## ANN ARBOR HISTORIC DISTRICT COMMISSION

### Staff Report

**ADDRESS:** 208 South Main Street, Application Number HDC12-138

**APPLICATION:** The applicant seeks HDC approval to 1) remove some of the existing green marble veneer and replace it with new black granite, 2) remove the existing fabric awning and replace it with a new steel frame canopy, 3) install a new wall sign above the proposed canopy, and 4) replace two metal grilles with new metal signs.

## PROPOSED ELEVATION

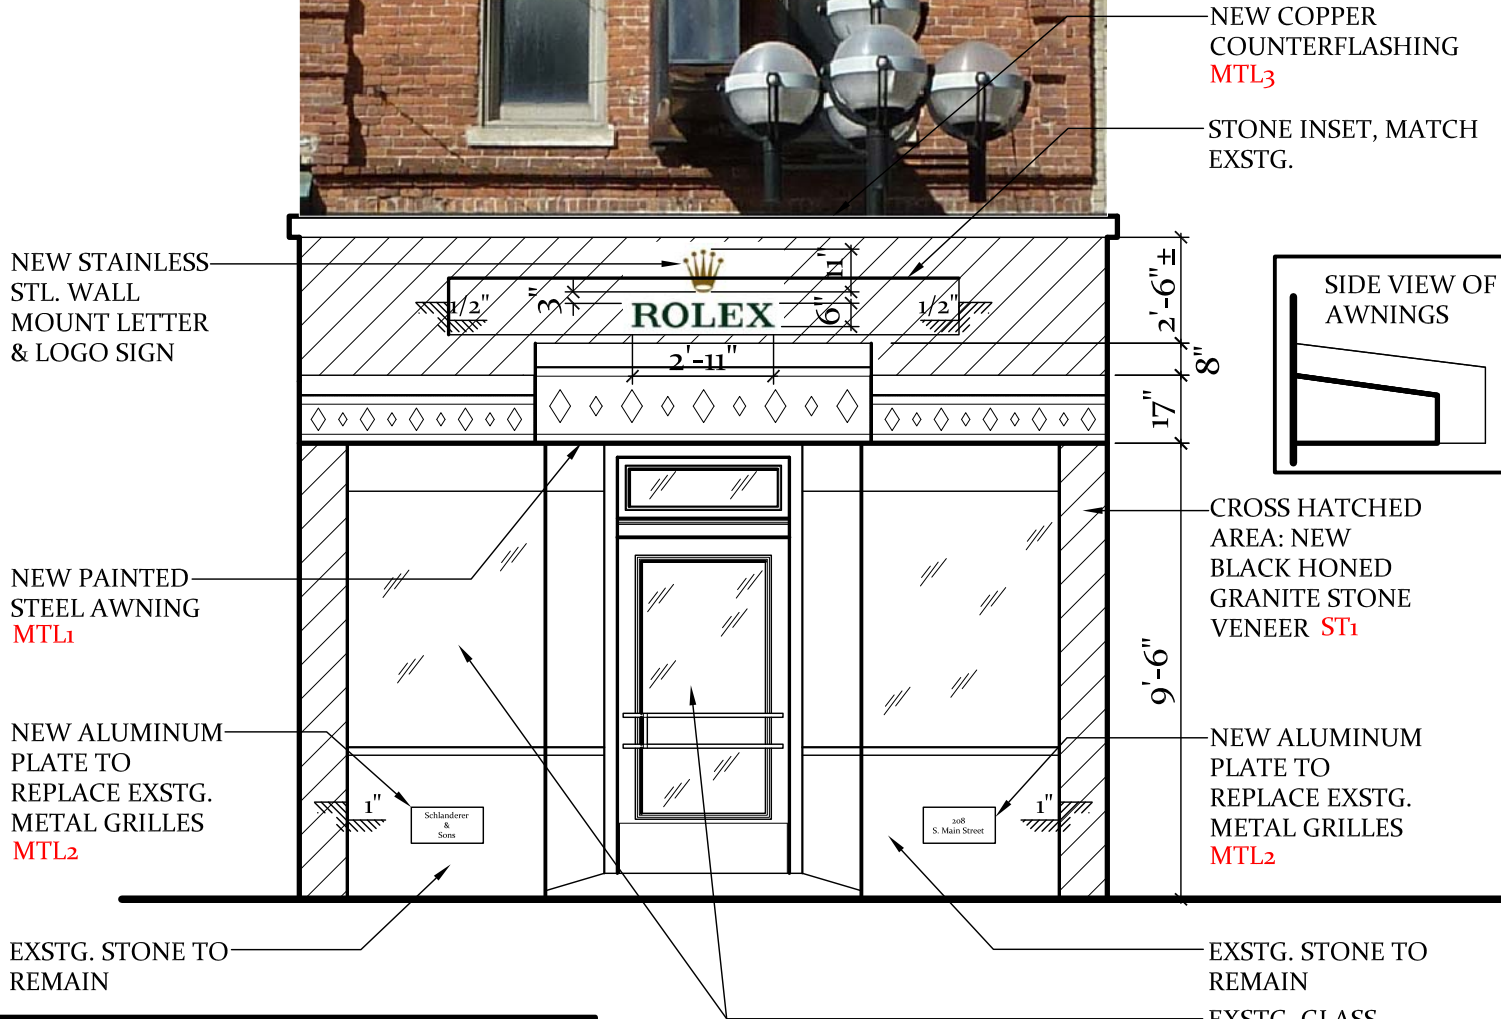
4. The applicant proposes to remove the existing retractable canvas awning and replace it with a rigid steel canopy. In comparison to the canopy proposal submitted last month, the brackets on each end of the roof of the canopy have been removed, and the formerly flat top surface has been raised a few inches to make a very shallow slope. The proposed canopy measures approximately seventeen feet wide and will span the entire storefront. Above the windows the canopy will measure seventeen inches high and three feet deep. Above the door it will measure twenty-five inches high and four feet deep. The proposed canopy will have a steel frame and will be mounted into the stone façade. The canopy appears to meet building code requirements for size and height.

6. In relation to SOI standards 2, 9 and 10, and the guidelines for storefronts, the canopy would not destroy historic materials, would be reversible, and is differentiated from the historic features of the building. However, the architectural features of the canopy are not compatible with the front elevation of the building, and the steel canopy would replace the awning, which is an existing functional and decorative feature of the storefront.

11. Staff believes that the proposed canopy is inappropriate. While alternate materials to a canvas awning may be acceptable, the shallowly sloping design does not convey the look or feel of an awning, which would traditionally be found on this building. The proposed work is generally incompatible in exterior design, arrangement, texture, material and relationship to the rest of the building and the surrounding area and does not meet *The Secretary of the Interior's Standards for Rehabilitation*, in particular standards 2, 9 and 10, and the guidelines for storefronts.

## AWNING REFLECTED CEILING

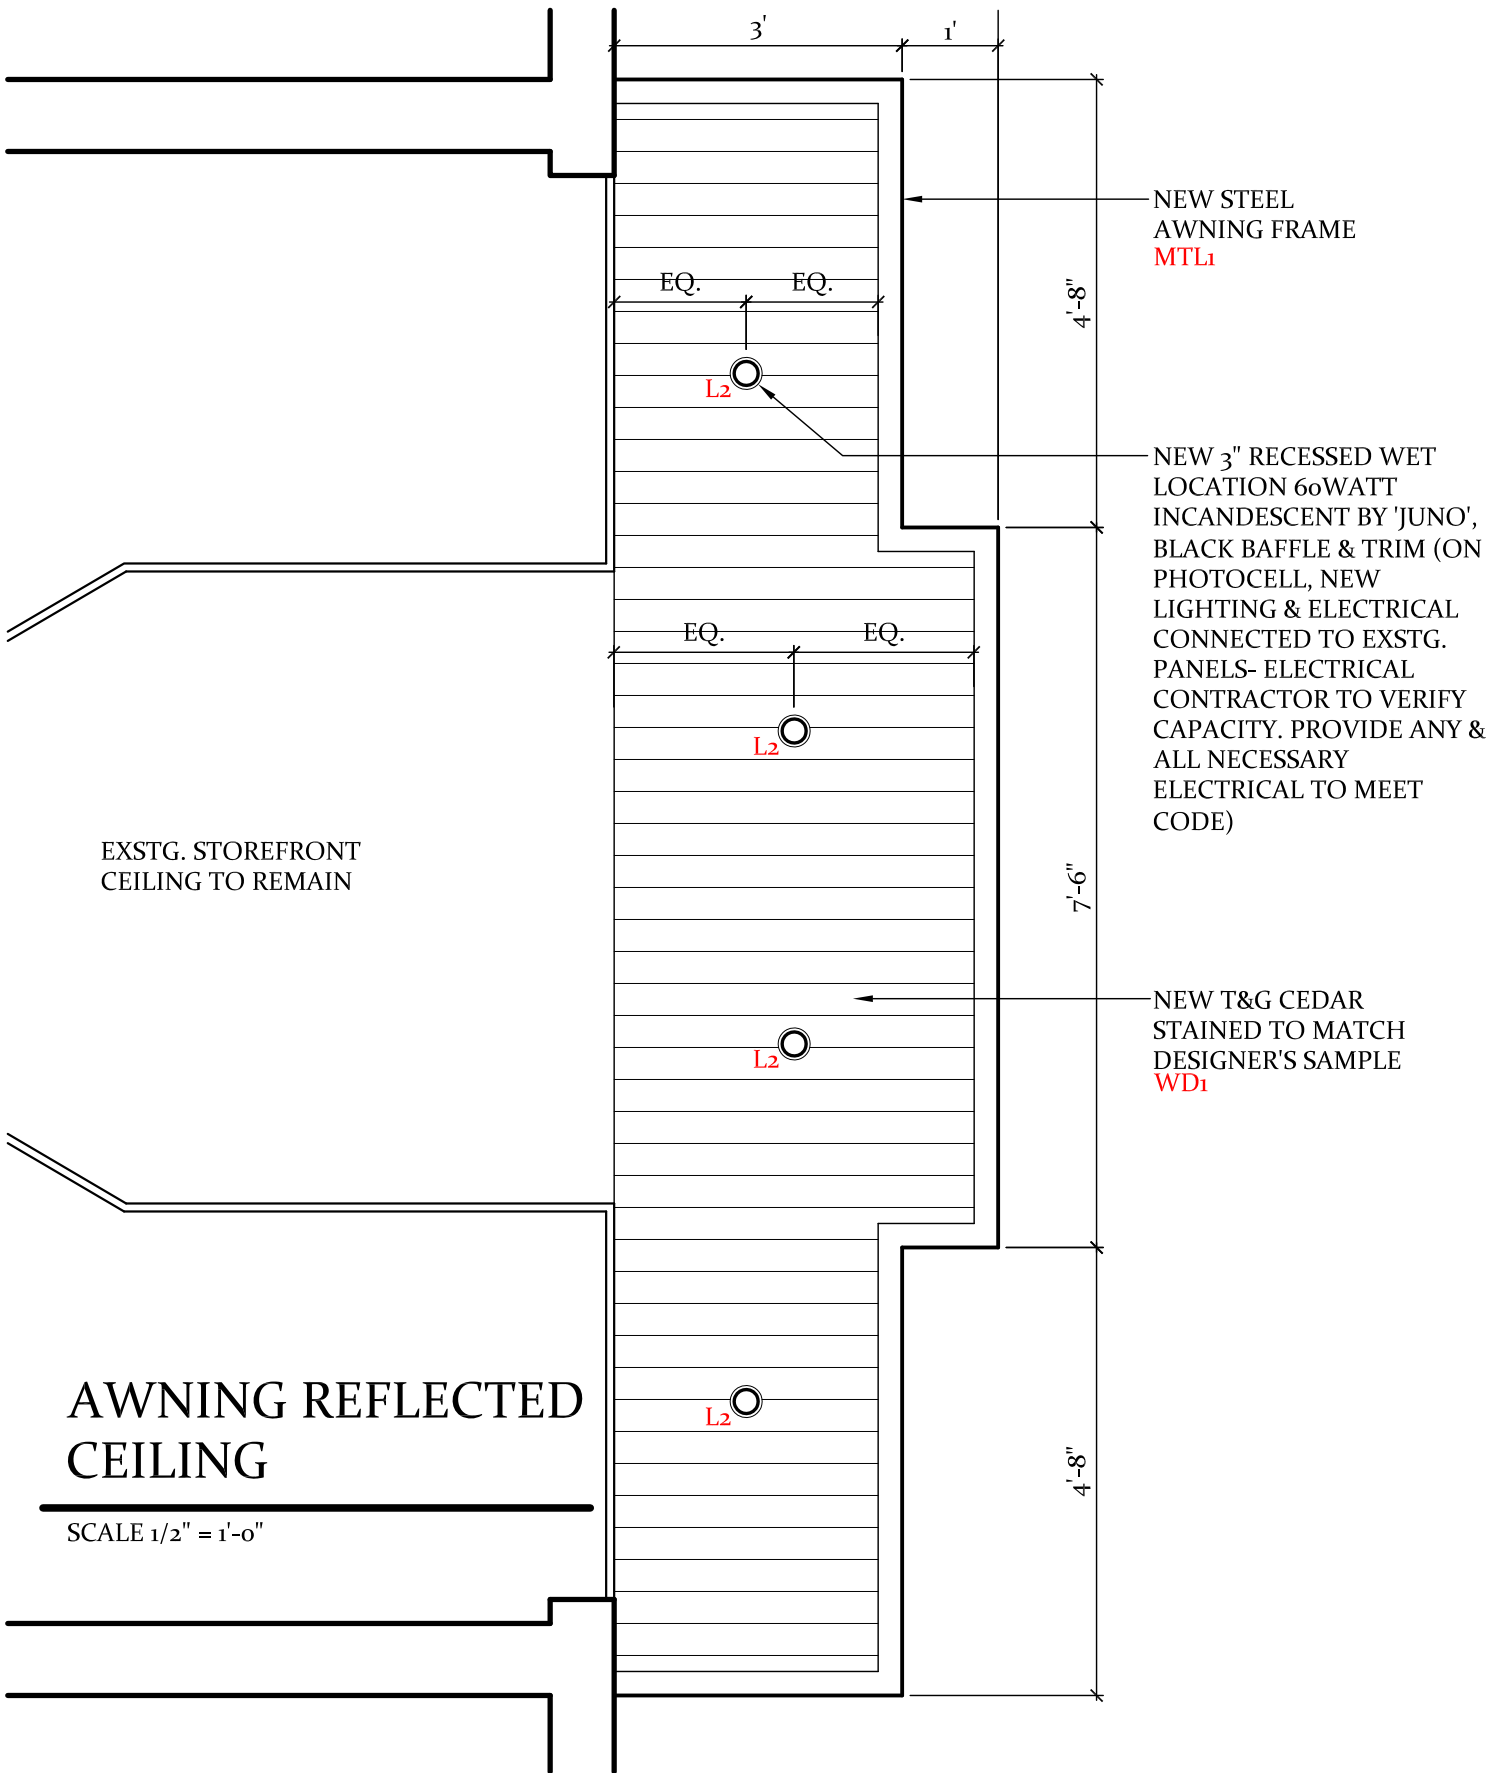
5. The proposed canopy has a stained wood "ceiling" with four recessed lights. The wood ceiling will be tongue and groove cedar stained a dark brown color. The "roof" of the canopy will have one small spotlight to illuminate the proposed wall sign located on the façade above the canopy. Based on the provided mock ups, the entire canopy will be painted beige and will have copper flashing on the raised portion along the front edge. The existing canvas awning is much more typical of a small downtown storefront than the proposed canopy. The historic documentation (photos) that staff was able to find all showed canvas awnings on this and neighboring storefronts.

## DETAIL OF NEW STONE ATTACHMENT

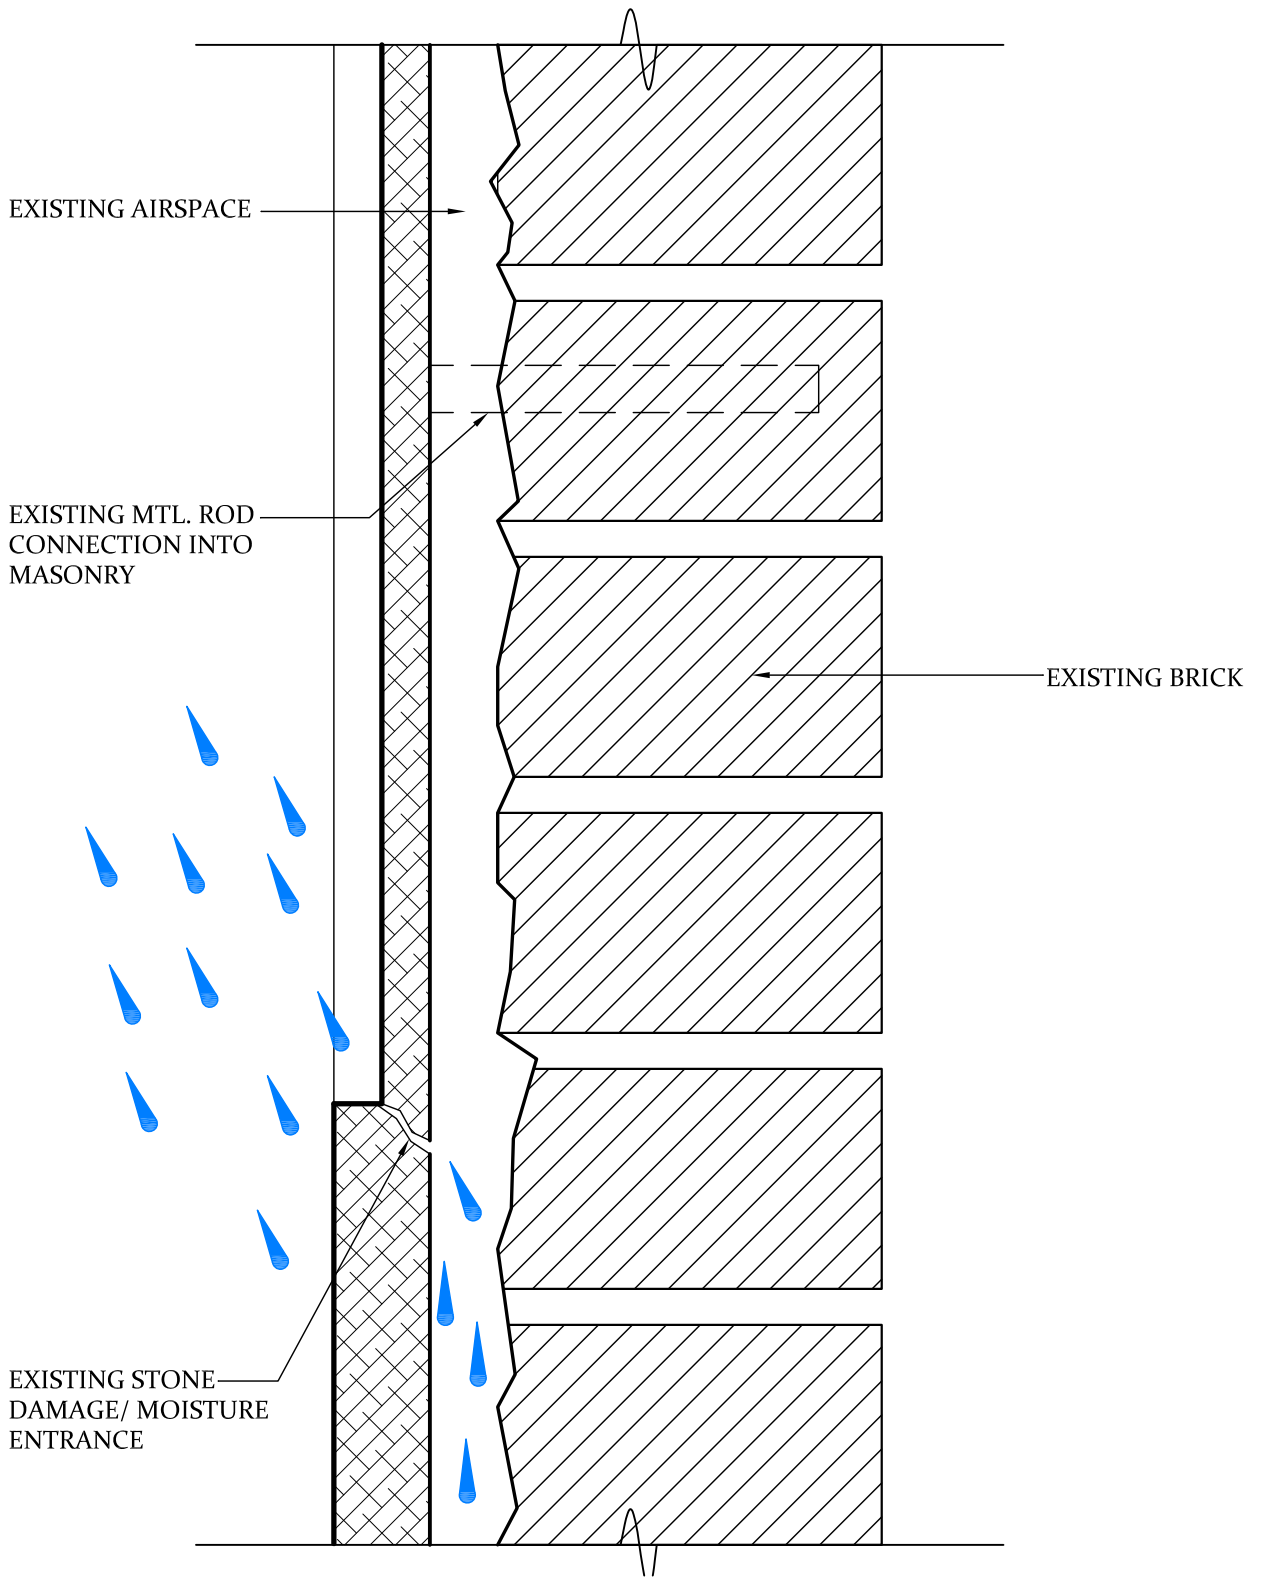
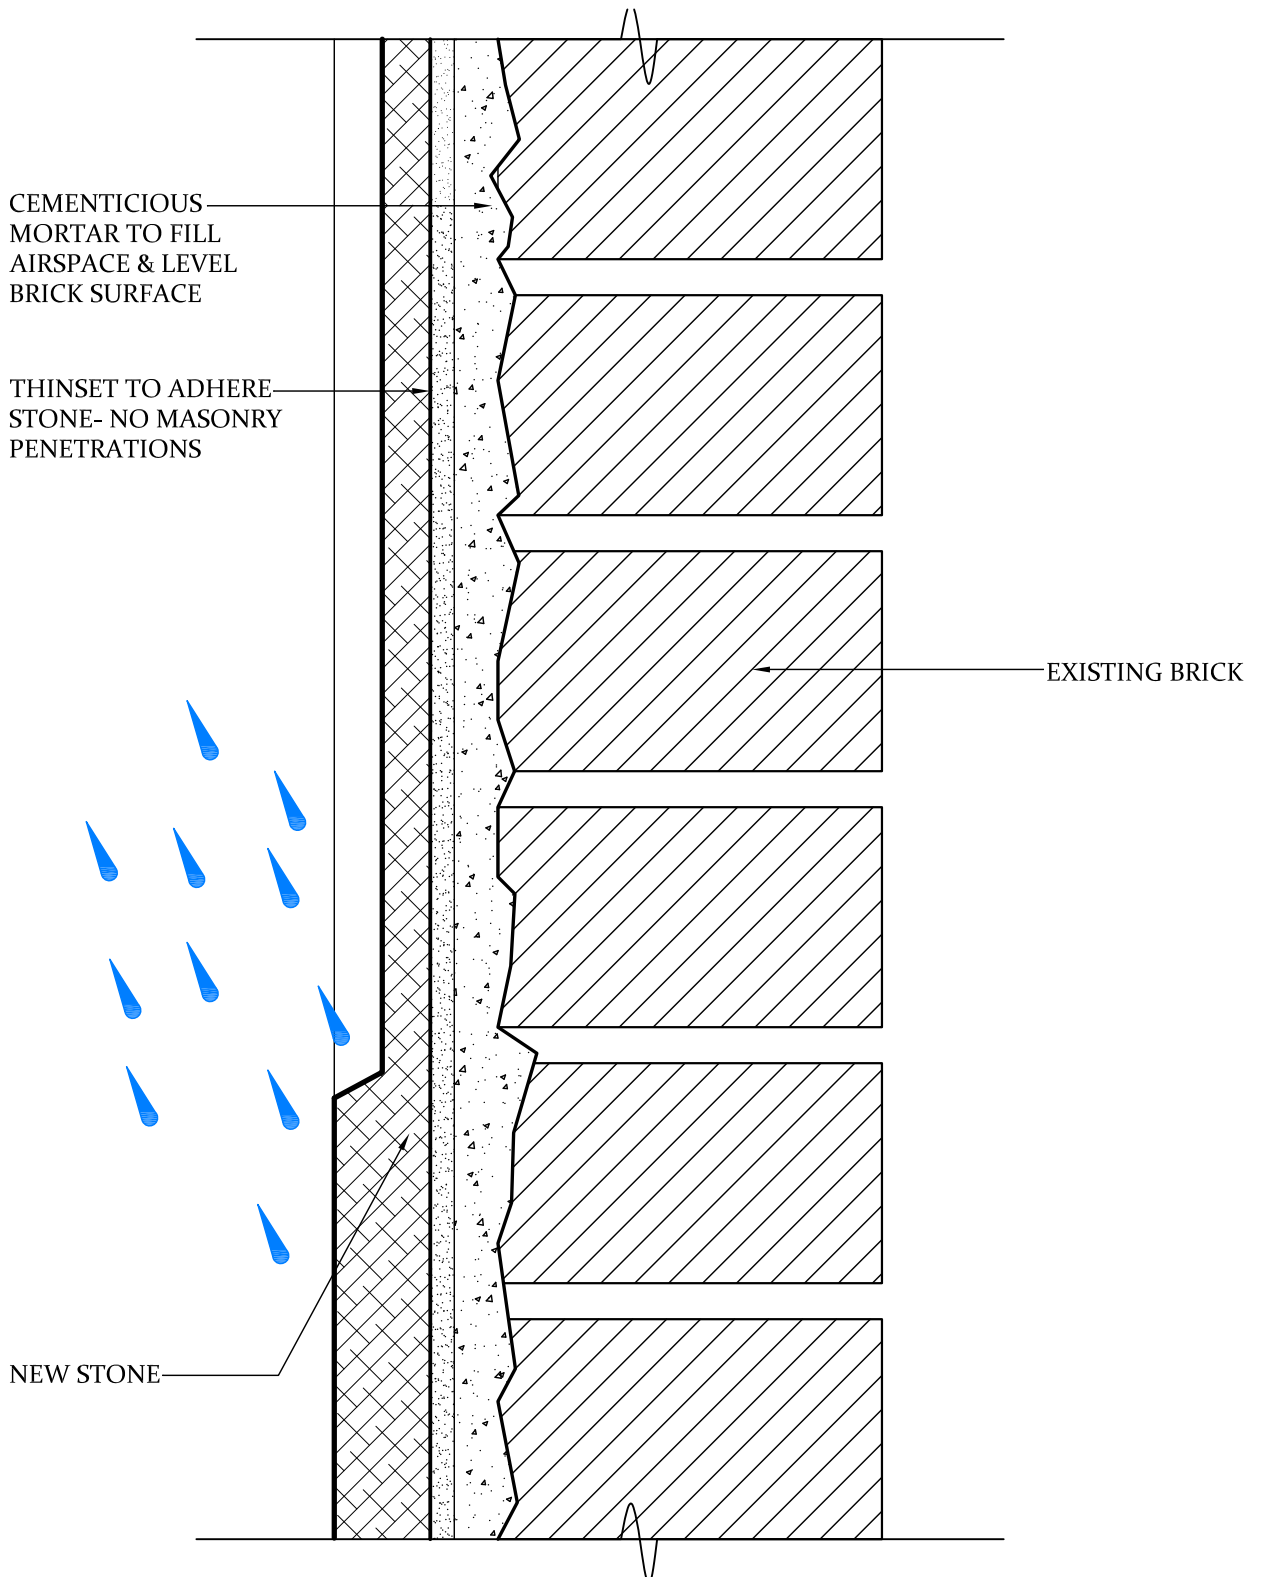
3. Before attaching the new stone veneer, the applicant proposes filling the gaps between the existing brick and proposed veneer with a cementitious mortar. The stone veneer will then be attached to the mortar, so none of the bricks are damaged.
